SERVICE BULLETIN

N° **139-444**

REV. : C - June 28, 2018

ATA 78 - EXHAUST DUCTS AND REAR FIREWALL RETROMOD

Figure 1

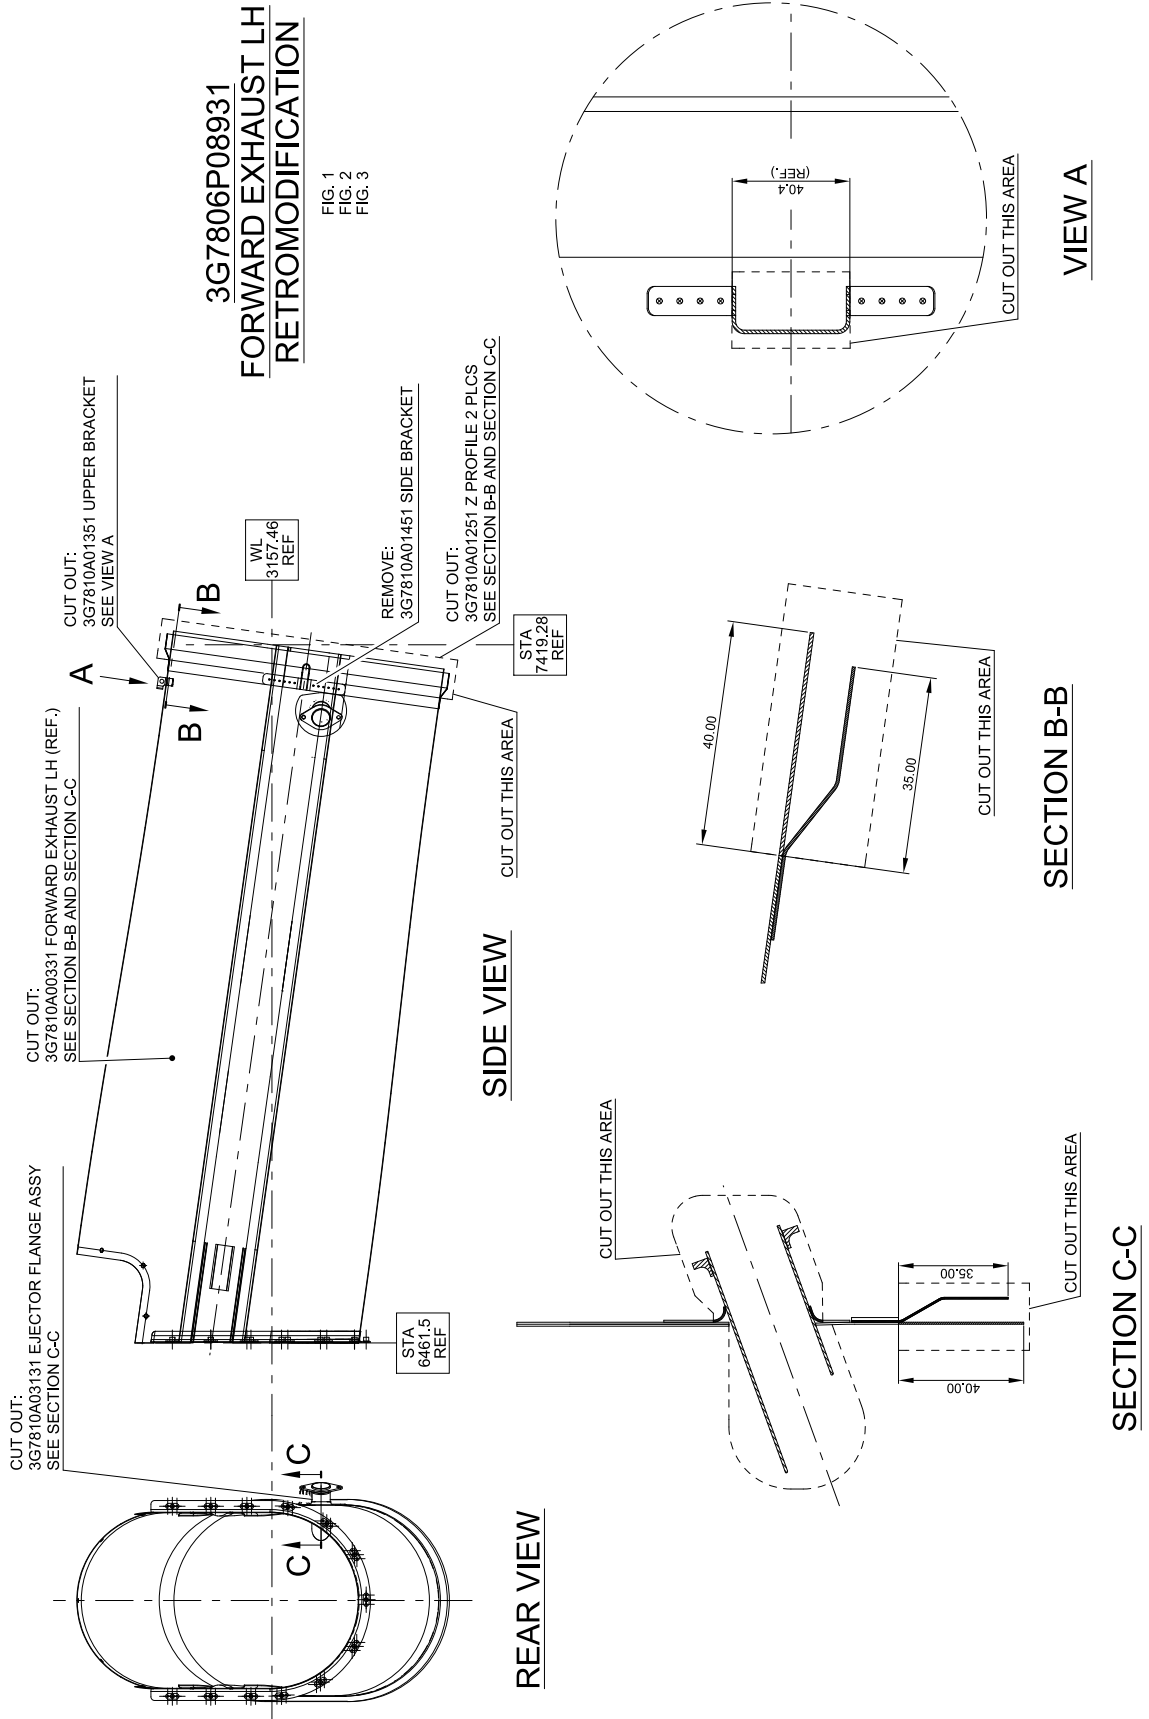
- 3.1 With reference to Figure 1 section B-B and section C-C, perform indicated cut out of Z profile P/N 3G7810A01251 and forward exhaust LH P/N 3G7810A00331.

- 3.2 With reference to Figure 1 view A, perform cut out of the upper bracket P/N 3G7810A01351.

- 3.3 With reference to Figure 1 section C-C, perform the indicated cut out of the ejector flange P/N 3G7810A03131.

- 3.4 With reference to Figure 1 side view, cut out the existing side bracket P/N 3G7810A01451.
- 3.5 With reference to Figure 3 view F, temporarily locate the upper bracket P/N 3G7810A10652 and countermark position of n°8 rivet holes on forward exhaust LH.
- 3.6 With reference to Figure 3 view F, drill n°8 rivet holes $\varnothing 3.18 \div 3.43$ in the previously marked positions.
- 3.7 With reference to Figure 3 view F, install the upper bracket P/N 3G7810A10652 by means of n°8 rivets P/N MS20615-4M5.

Figure 2

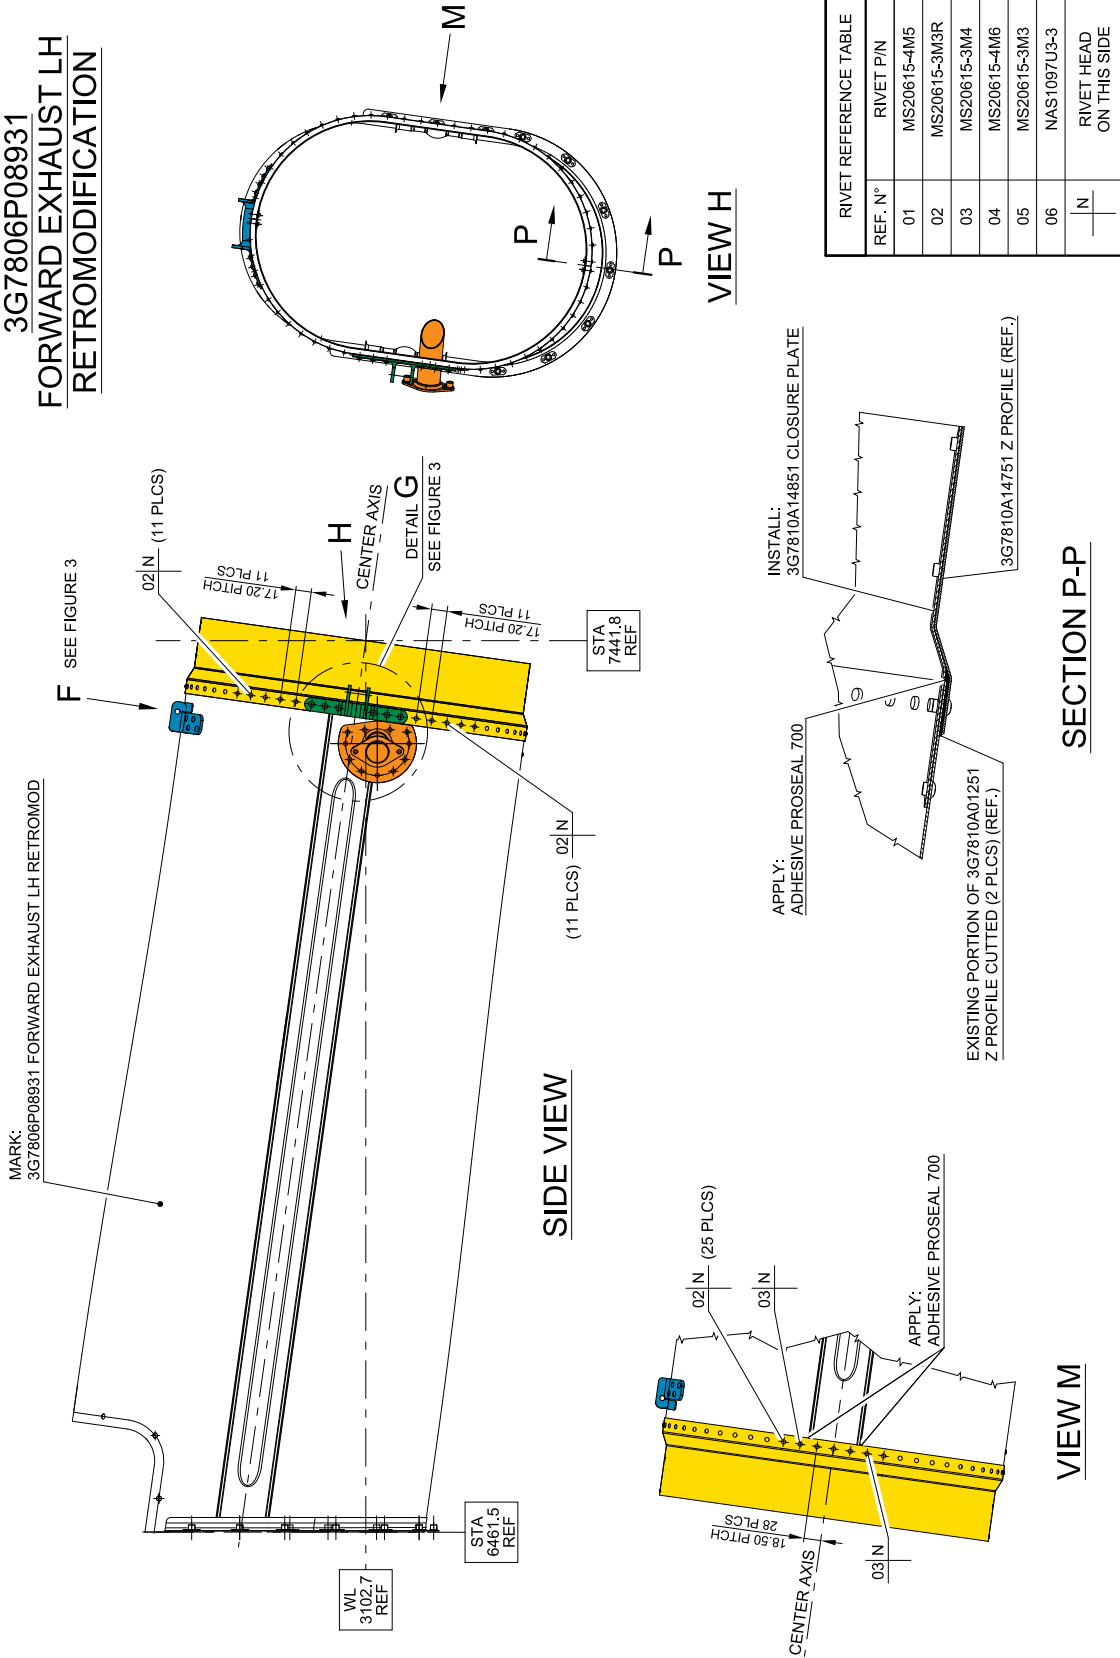
- 3.10 With reference to Figure 2 and Figure 3 view F, on the two Z profiles, drill n°53 rivet holes $\varnothing 2.36 \div 2.62$ and n°6 rivet holes $\varnothing 3.18 \div 3.43$ in the previously marked positions.

- 3.11 With reference to Figure 2 and Figure 3 view F, enlarge existing pilot holes on the two Z profiles and the two closure plates to $\varnothing 2.36 \div 2.62$.

- 3.14 With reference to Figure 2 view M, section P-P, Figure 3 view F, and section N-N, install n°2 Z profiles P/N 3G7810A14751 by means of n°6 rivets P/N MS20615-3M4 and n°47 rivets P/N MS20615-3M3R.
- 3.15 With reference to Figure 3 detail G, temporarily locate side bracket P/N 3G7810A10751 and countermark the positions of n°6 rivet holes.
- 3.16 With reference to Figure 3 detail G, drill on the side bracket n°6 rivet holes $\varnothing 3.18 \div 3.43$ in the previously marked positions.
- 3.17 With reference to Figure 3 detail G, install side bracket P/N 3G7810A10751 by means of n°6 rivets P/N MS20615-4M6. Seal all around the side bracket by means of Proseal 700.

Figure 3

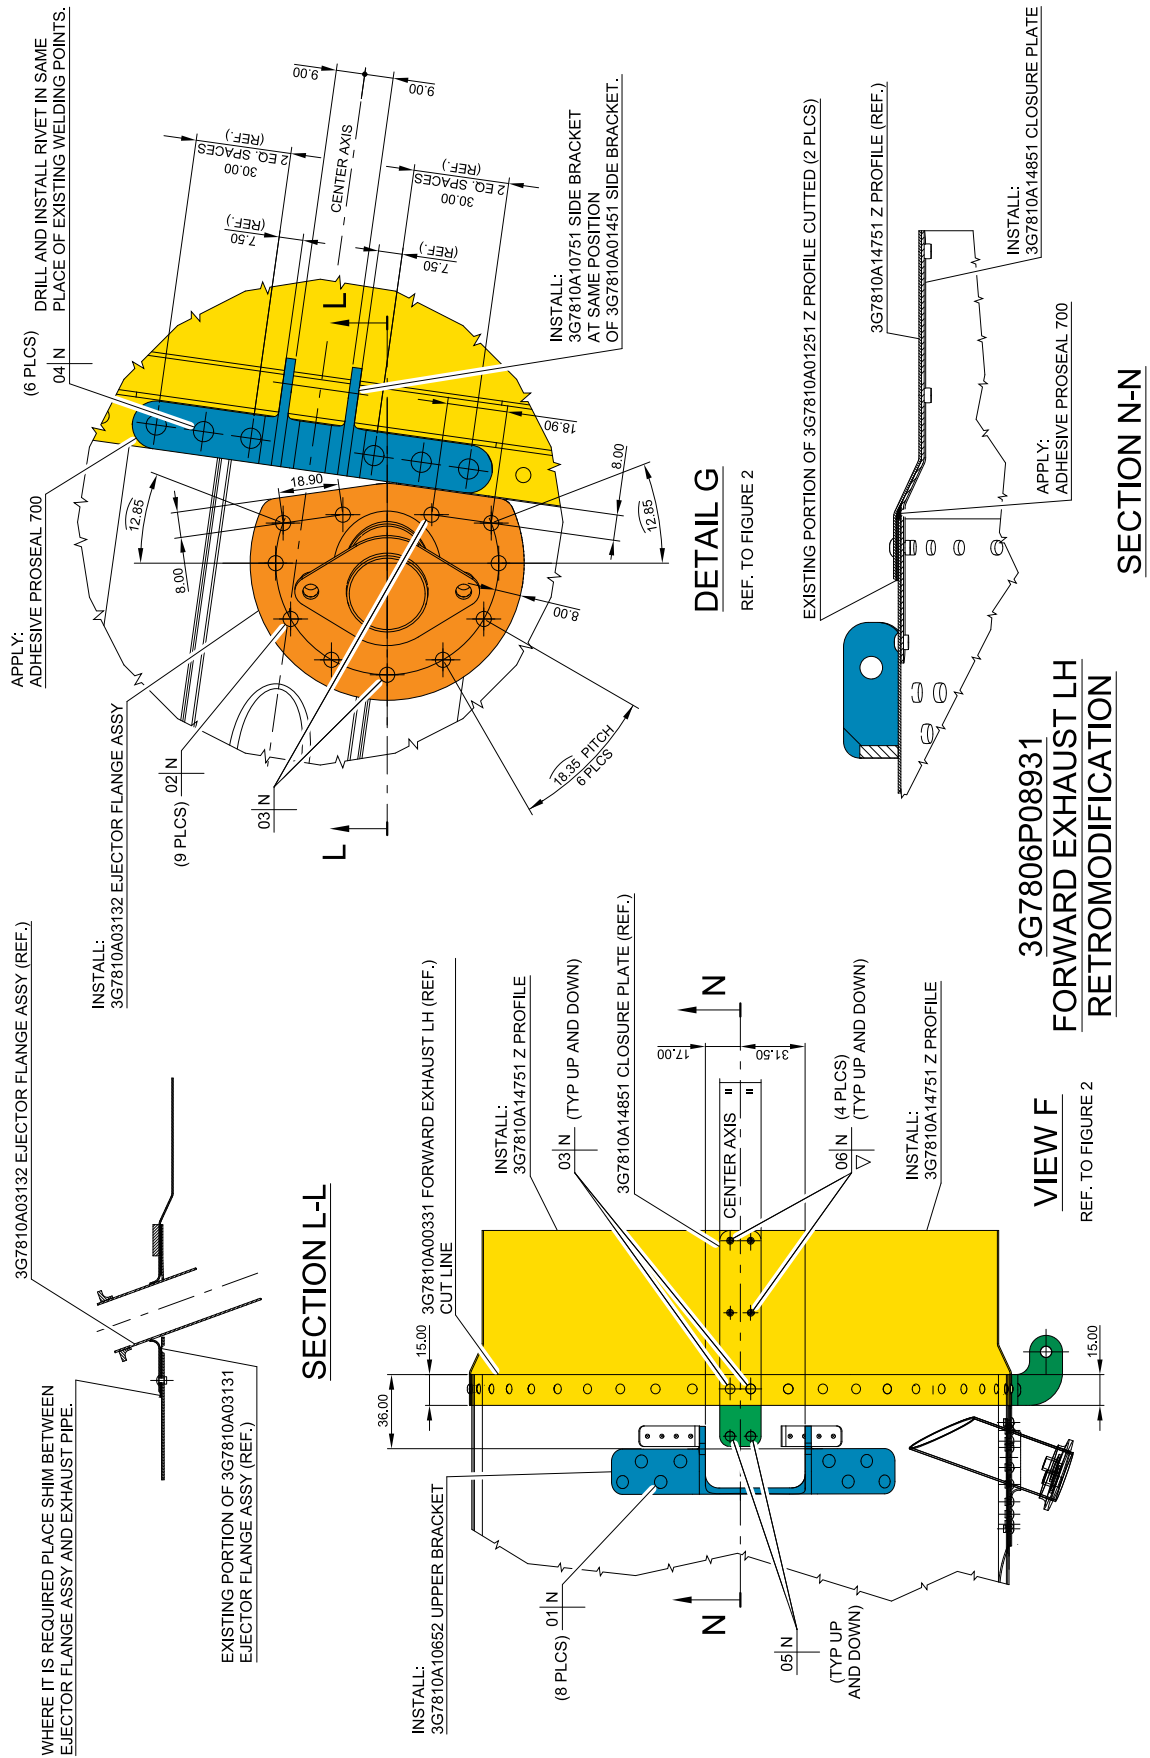
- 3.8 With reference to Figure 3 section N-N, remove the portion of Z profile damaged and replaced it with a shim with the same dimensions (material AMS5525 Stainless steel plate THK 0.64 mm).

- 3.9 With reference to Figure 3 view F and section N-N, temporarily install n°2 Z profiles P/N 3G7810A14751 and n°2 closure plates P/N 3G7810A14851. Countermark on Z profiles the positions of n°59 rivet holes and the positions of n°4 rivet holes in the forward exhaust.

- 3.12 With reference to Figure 3 view F and section N-N, drill on the forward exhaust n°4 holes $\varnothing 2.36 \div 2.62$, in the previously marked positions.

- 3.13 With reference to Figure 3 view F and section N-N, install together n°2 Z profiles P/N 3G7810A14751 and n°2 closure plates P/N 3G7810A14851 by means of n°8 rivets P/N NAS1097U3-3. Seal any openings by means of Proseal 700.

- 3.18 With reference to Figure 3 detail G and section L-L, temporarily locate ejector flange assembly P/N 3G7810A03132 and countermark position of n°11 rivet holes at positions shown.
 - 3.19 With reference to Figure 3 detail G, drill n°11 rivet holes $\varnothing 2.36 \div 2.62$, in previously marked position.
 - 3.20 With reference to Figure 3 detail G, install ejector flange assy P/N 3G7810A03132 by means of n°9 rivets P/N MS20615-3M3R and n°2 rivets P/N MS20615-3M4.
 - 3.21 With reference to Figure 2, mark P/N 3G7806P08931 in a visible area on the reworked forward exhaust LH, by means of an indelible pen.
4. Send the attached compliance form to the following mail box:

Figure 4

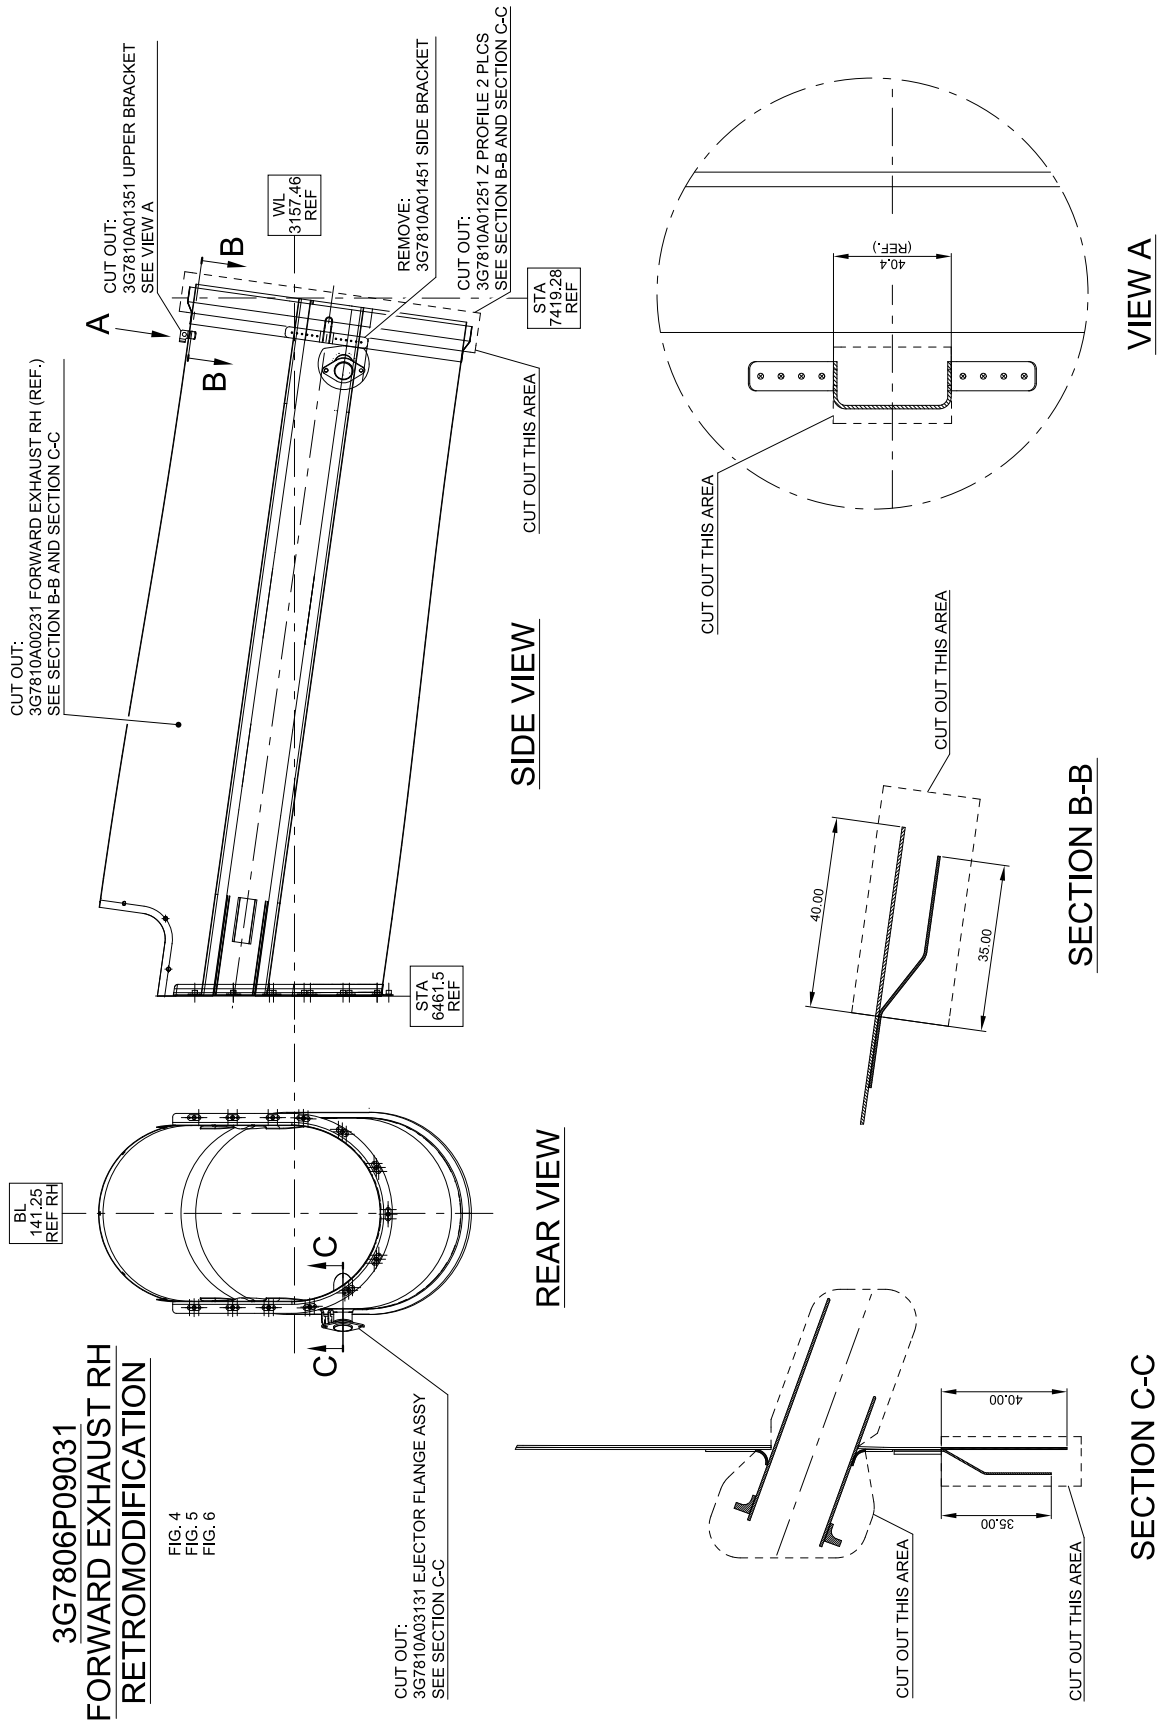
- 3.1 With reference to Figure 4 section B-B and section C-C, perform cut out of Z profile P/N 3G7810A01251 and forward exhaust RH P/N 3G7810A00231.

- 3.2 With reference to Figure 4 View A, perform cut out of the upper bracket P/N 3G7810A01351.

- 3.3 With reference to Figure 4 Section C-C, perform cut out of the ejector flange P/N 3G7810A03131 as shown.

- 3.4 With reference to Figure 4, cut of the existing side bracket P/N 3G7810A01451.
- 3.5 With reference to Figure 6 view F, temporarily locate the upper bracket P/N 3G7810A11452 and countermark position of n°8 rivet holes on forward exhaust RH.
- 3.6 With reference to Figure 6 view F, drill n°8 rivet holes $\varnothing 3.18 \div 3.43$ in previously marked positions.
- 3.7 With reference to Figure 6 view F, install upper bracket P/N 3G7810A11452 by means of n°8 rivets P/N MS20615-4M5.

Figure 5

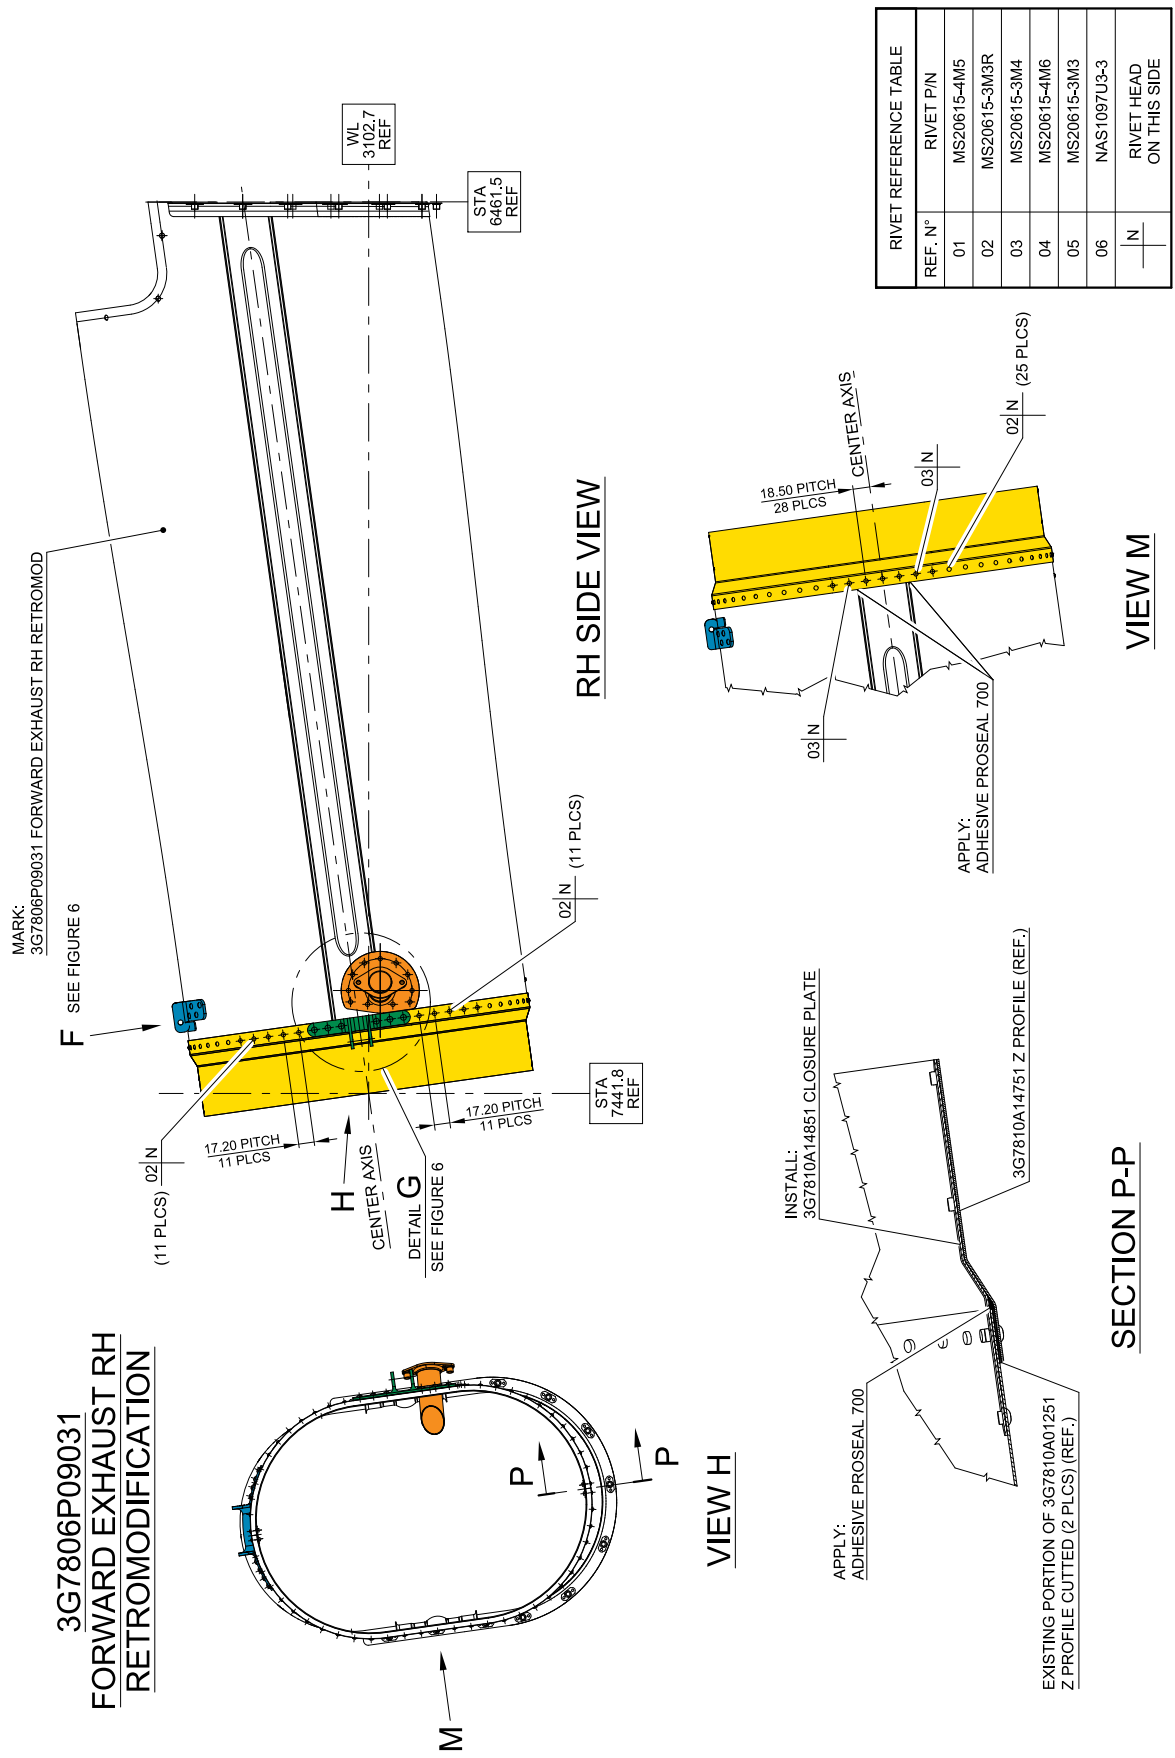
- 3.10 With reference to Figure 5 and Figure 6 view F, on the two Z profiles, drill n°53 rivet holes $\varnothing 2.36$ to 2.62 and n°6 rivet holes $\varnothing 3.18 \div 3.43$ in the previously marked points.

- 3.11 With reference to Figure 5 and Figure 6 view F, enlarge existing pilot holes on the two Z profiles and the two closure plates to $\varnothing 2.36 \div 2.62$.
